**FINAL ENVIRONMENTAL IMPACT STATEMENT**

**IIAUULA 180 RESERVOIR AND BOOSTER STATION**  
(TMK 5-4-4:4 and TMK 5-4-19:54)

Board of Water Supply  
City and County of Honolulu  
630 South Beretania Street  
Honolulu, Hawaii 96843

Engineering Design Group, Inc.  
1525 Young Street  
Honolulu, Hawaii 96826

**FIGURE 5**  
**Reservoir Site Grading Plan**  
**Hauula 180 Reservoir**

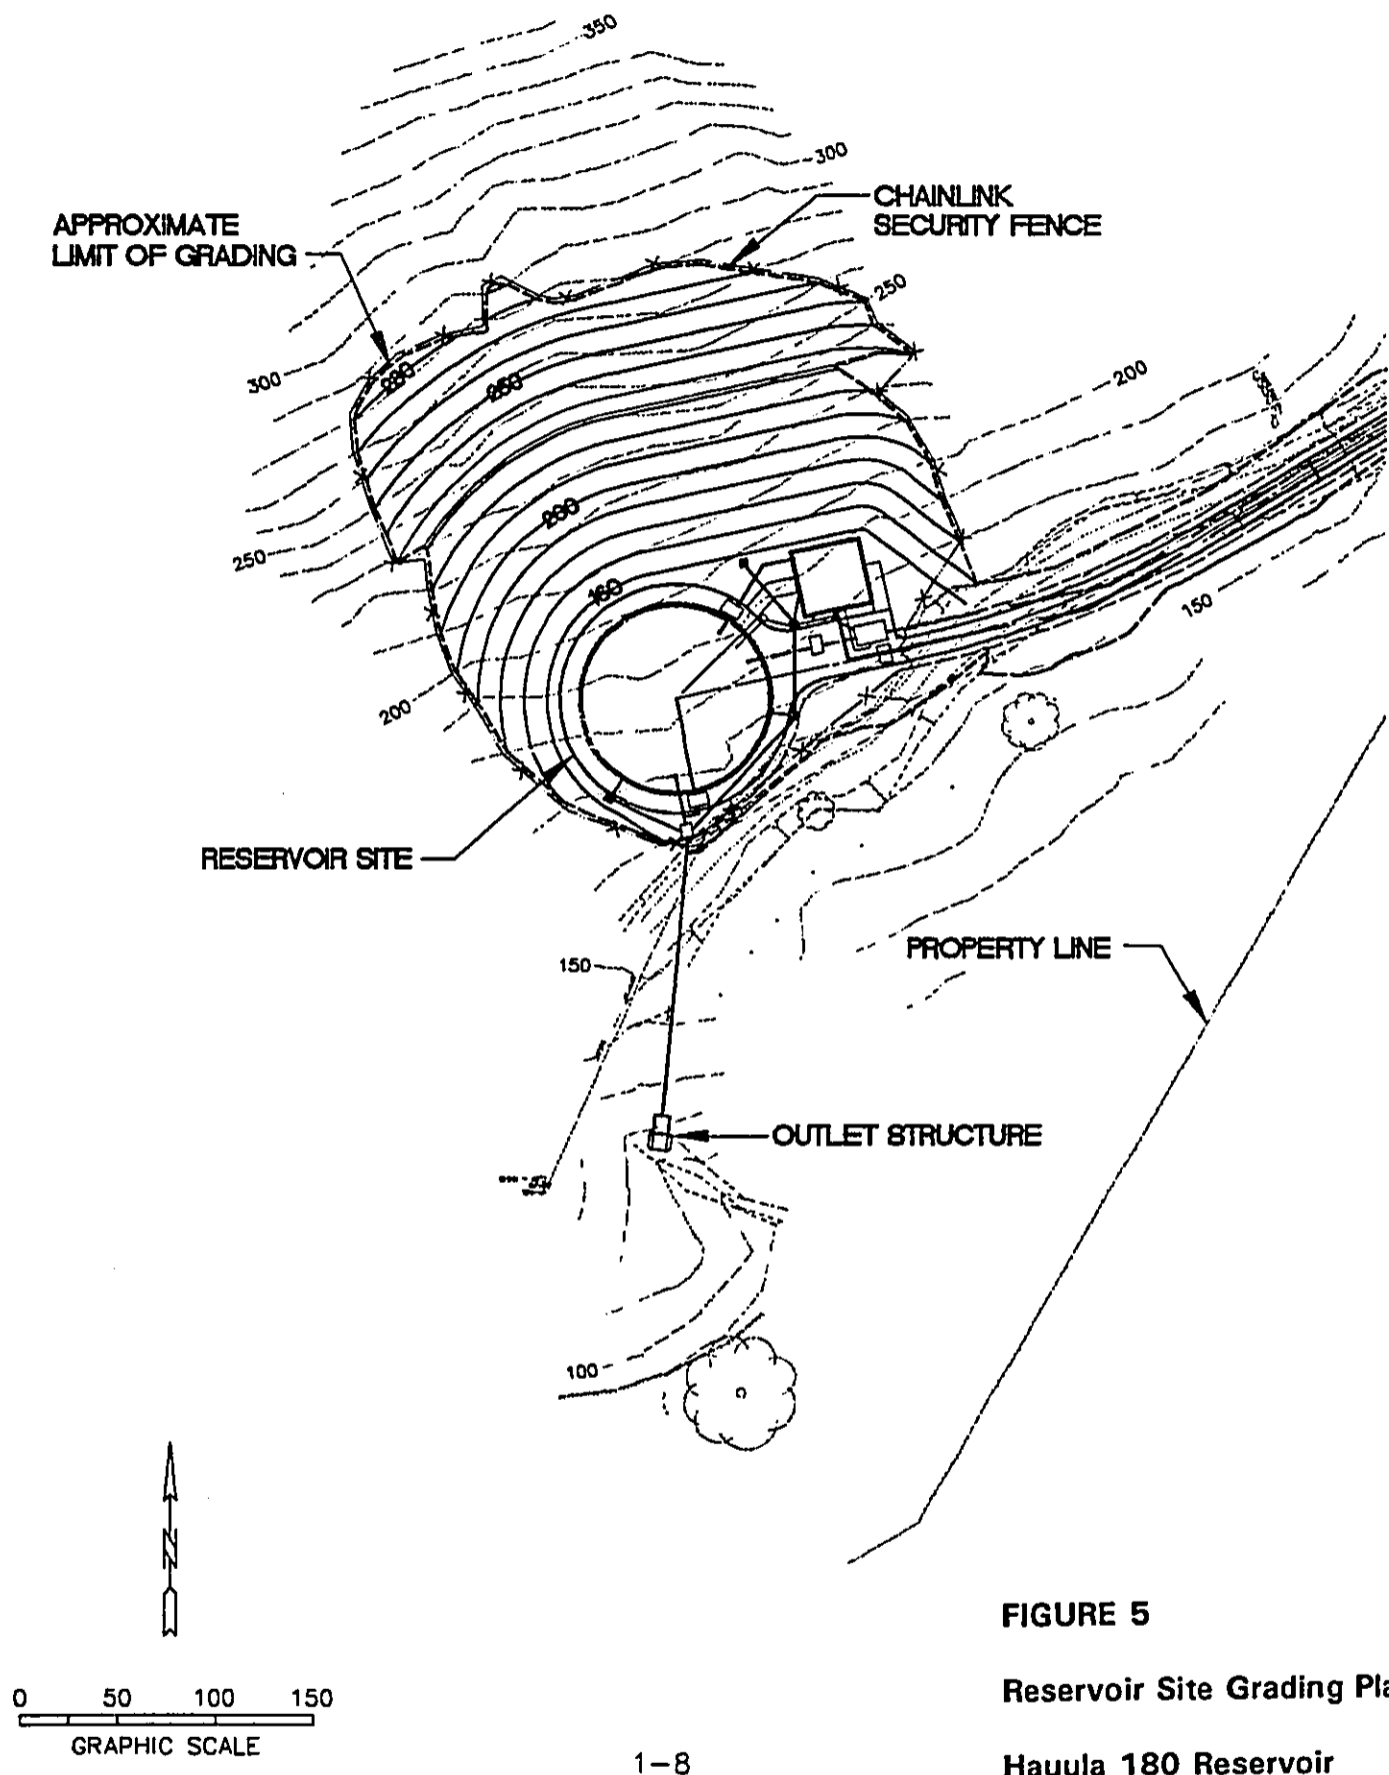
The proposed grading plan indicates a wide expanse of grading uphill of the proposed reservoir (see Figure 5, page I-4a). Discussion of the proposed grading plan should include an explanation of the extensive grading.

1. The waterlines along Kawaipuna Street are within the Special Management Area (SMA); however, their location in a public roadway should exempt them from SMA regulations. The new access road and proposed reservoir are outside of the SMA and are not subject to SMA regulations. Refer to the attached map which shows the proposed project in relation to the SMA.
2. The proposed grading plan is being designed and final plans will be shown in the Final EIS. Details of grading for the entire project will be submitted as part of the construction review and permit process. The proposed grading plan is based on a maximum cut slope of 1.2:1, as recommended by the soils engineer for slope stability. An alternate site would require a larger cut area than what is proposed. As part of the mitigative action for the visual impacts, landscaping for the reservoir will be provided.
